# RIFT: Routing in Fat Trees

## Base Spec Update

IETF114

# What do I mean by “not parallel”?

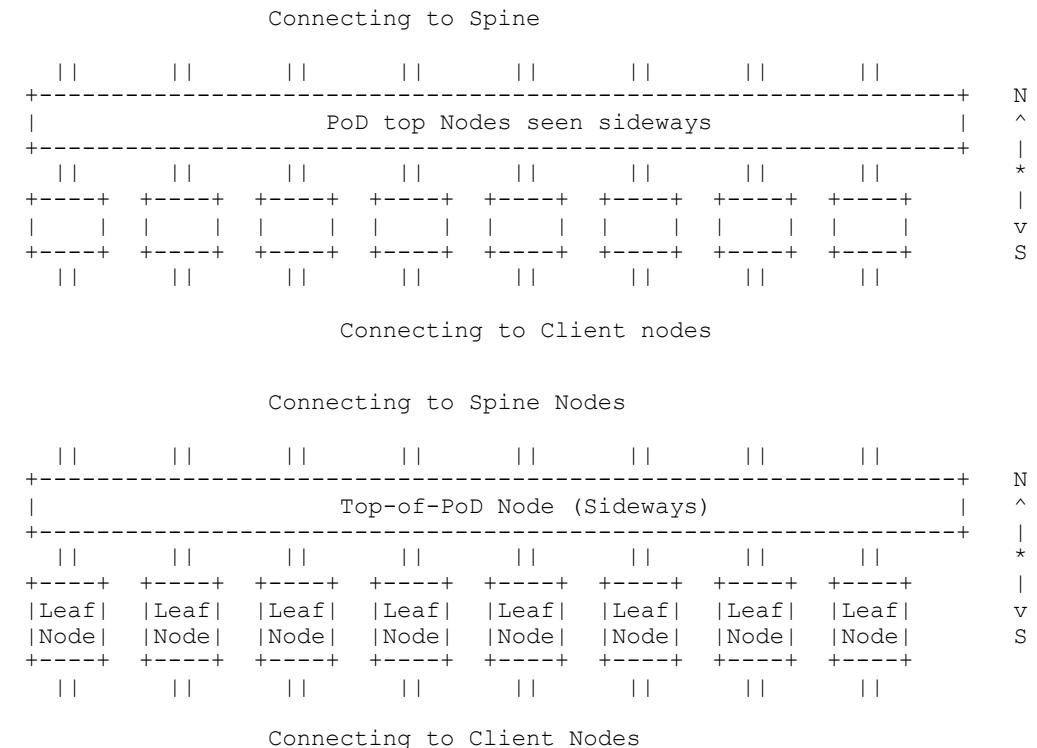
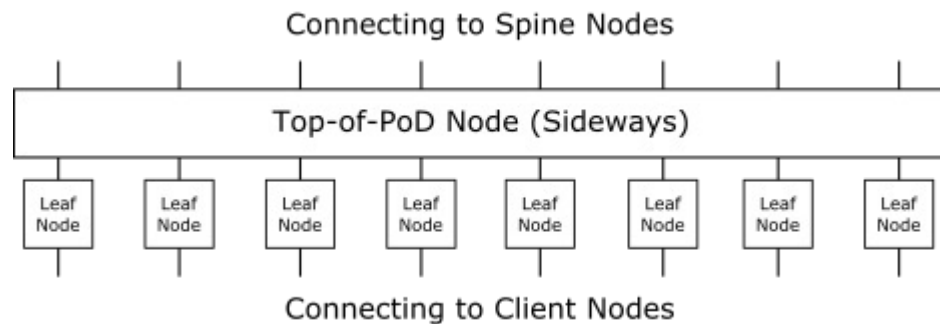
- **Inconsistent labels:** “PoD top Nodes” rather than “Top-of-PoD Node”.
  - The latter properly aligns with the draft’s text as well.
- **Lack of labels:** “Leaf Node”.
